ADDENDUM TWO

Addendum Two to the drawings and specifications prepared by Myszak+Palmer for **Hutsonville Fire Station**, Hutsonville, Illinois.

Z812

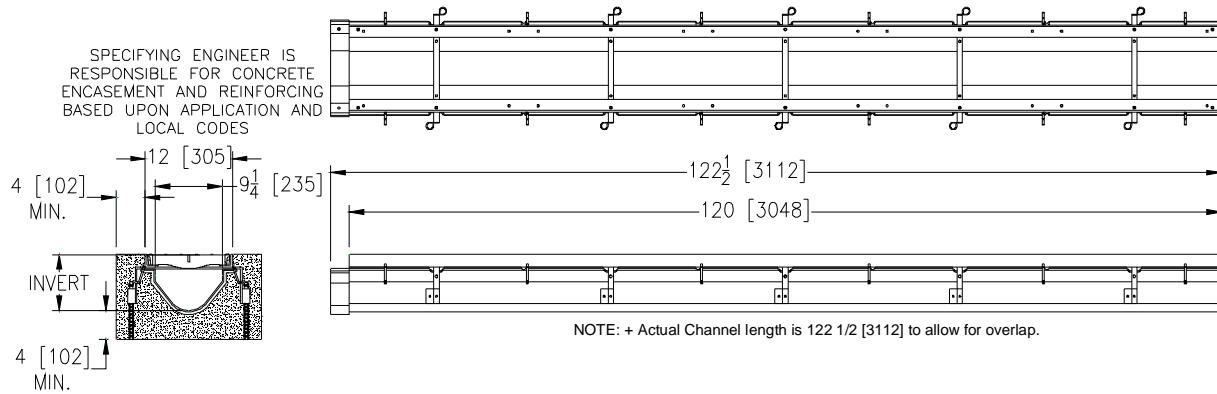
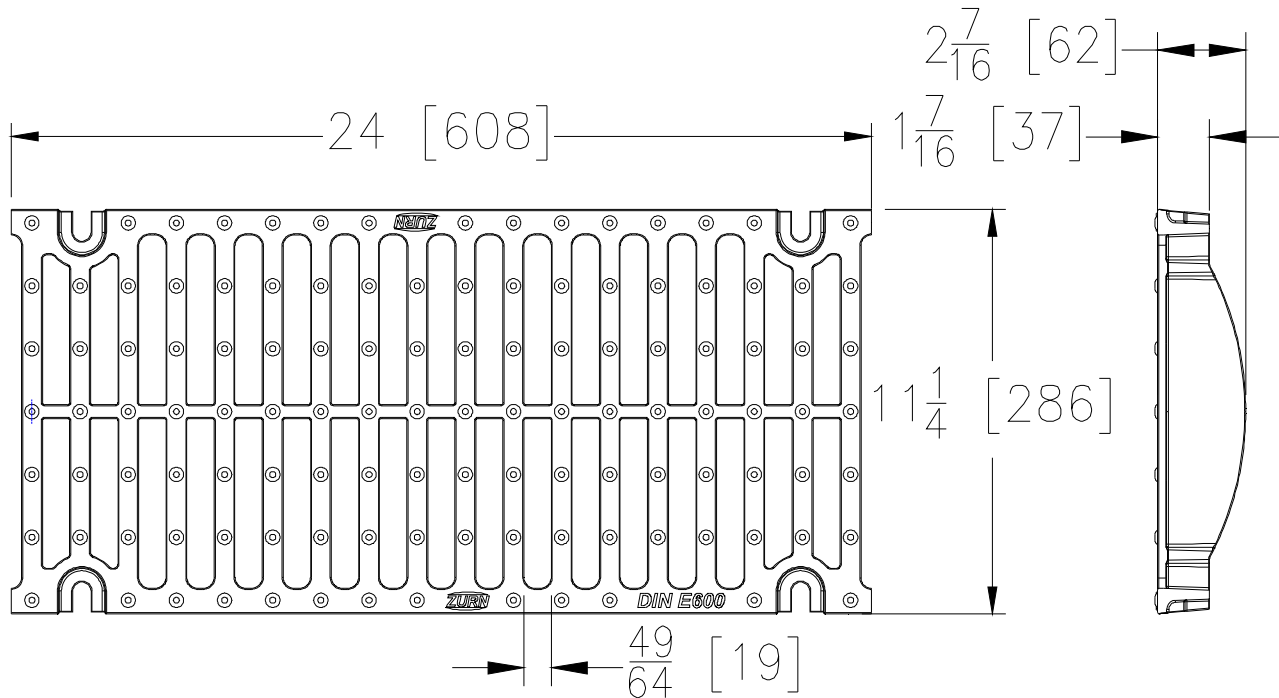
- 5. Specification Section TRENCH DRAINS – ACCEPTABLE EQUAL**
- A. **ZURN Z812** – Shall be considered an acceptable equal to the trench drains shown on Sheet P1.1.

- B. See attached Specification Sheet and Installation Instructions.
- 6. Specification Section 133419 ROOF PANEL – CLARIFICATION**
- A. **REMOVE** – Part 2.2 - Exterior Roof Panels

ADDENDUM 2 - DRAWING NO. 1

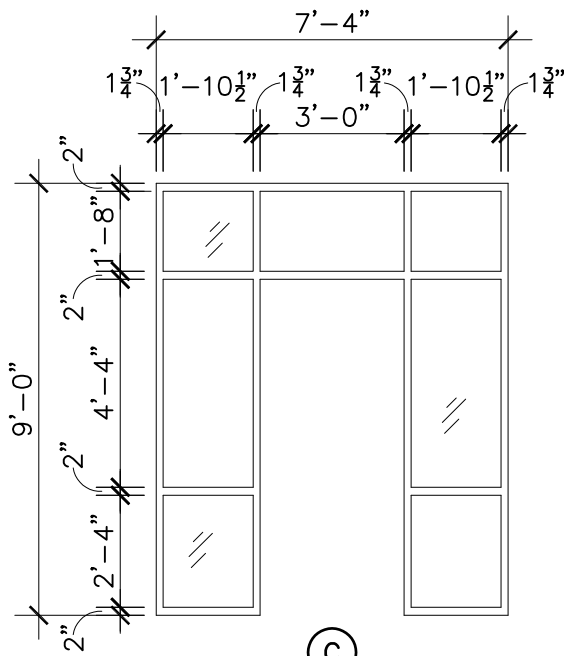
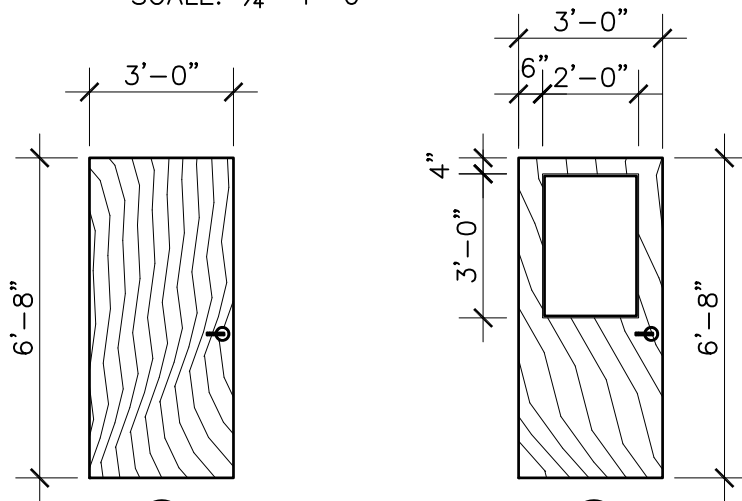
- 5. Drawing A5.2 CLARIFICATION – FRAME ELEVATION “C”**
- A. Head dimension shall be 2” in lieu of 3¾”
 - B. See attached updated Frame Elevation “C” – Drawing 1.

- 6. Drawing A5.2 CLARIFICATION – DOOR ELEVATION “2 & 3”**
- A. Wood doors shall be Marshfield-Enviroclad UV, Flush Wood – Solid Core Doors, plain-sliced Rotary Birch in Honey finish. Or equal.

- B. See attached updated Frame Elevation “C” – Drawing 1
- 7. Drawing S2 CLARIFICATION – TRENCH DRAIN DETAIL #9**
- A. See attached updated Trench Drain Detail #9 – Drawing 2
